**STAFF REPORT TO
THE BOARD OF ARCHITECTURAL REVIEW
PREPARED MAY 15, 2014**

FILE NUMBERS: L14-0015 – Design Review
E14-0003- SEPA

REQUEST: Construction of a 19 story residential and hotel mixed use building. The residential portion includes 370 units and the hotel includes 189 rooms. A total of 498 parking stalls are proposed.

LOCATION: 223 Andover Park East, Tukwila WA 98188

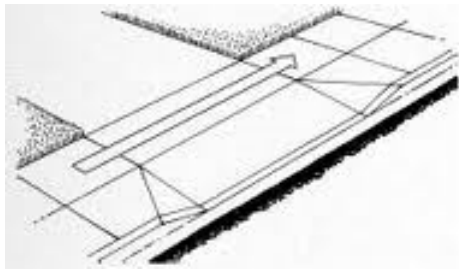
There are many healthy trees that line the north and south property lines. The existing trees are European Hornbeam, *Carpinus betulus fastigiata*, and based on their size are considered significant trees. Staff asked the applicant to preserve the existing trees as they not only provide canopy cover but also help screen the rear side of the buildings on the adjacent lots. Some of the buildings on the adjacent lots have completely blank walls with no windows, modulation or articulation and the trees help soften those facades. Applicant revised their plans to adjust interior parking lot islands so that a total of nine trees could be saved, however that means that the interior islands do not meet the spacing requirements of a maximum of 10 stalls between landscape islands. There are more than 40 trees that line the north and south property lines. There is an opportunity to save more trees and preserve the perimeter landscaping strip along the south property line by realigning the parking stalls to 60 degree angled parking and designating them as compact parking stalls. This option would leave an approximately 5'8" landscape perimeter along the south property line. Under this option the proposal would exceed overall interior landscaping requirements, but would not meet the requirement to have an island after every ten stalls. Additionally, the code states that a maximum 30% of the stalls can be compact stalls and this realignment will increase that percentage to more than 30%. However under TMC 18.70.090, the Board of Architectural Review may take into consideration the existing landscaping and modify the standards.

2. Preserve the existing perimeter trees along the north and south side to the maximum extent possible by realigning the parking stalls to 60 degree angled parking and designating them as compact parking stalls leaving at least 5'8" wide landscape perimeter along the south property line. In order to save the trees the Board is authorizing elimination of interior landscaping islands in lieu of the perimeter landscaping and also authorizing the percentage of compact stalls to exceed 30% of the total parking count.

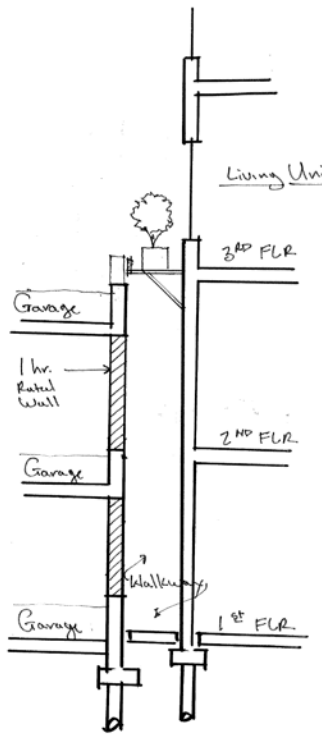
Primary common facilities are located inside the building or on the roof top. These facilities include a clubhouse, exercise rooms and pet area. No private open space for individual units is proposed. The entrance to the apartment lobby is separate from the hotel entrance.

There are a total of 208 surface parking stalls and 290 stalls are in the garage. The trash enclosure is screened from view at the pedestrian level and from above. The loading area in between the building and the garage is next to the hotel's pool area, but the applicant has stated it is an opaque wall and there will be no visibility from the hotel's pool area to the loading area. Additionally, the applicant has added a screen wall at the second floor hotel patio to shield views to the garage and the loading area.
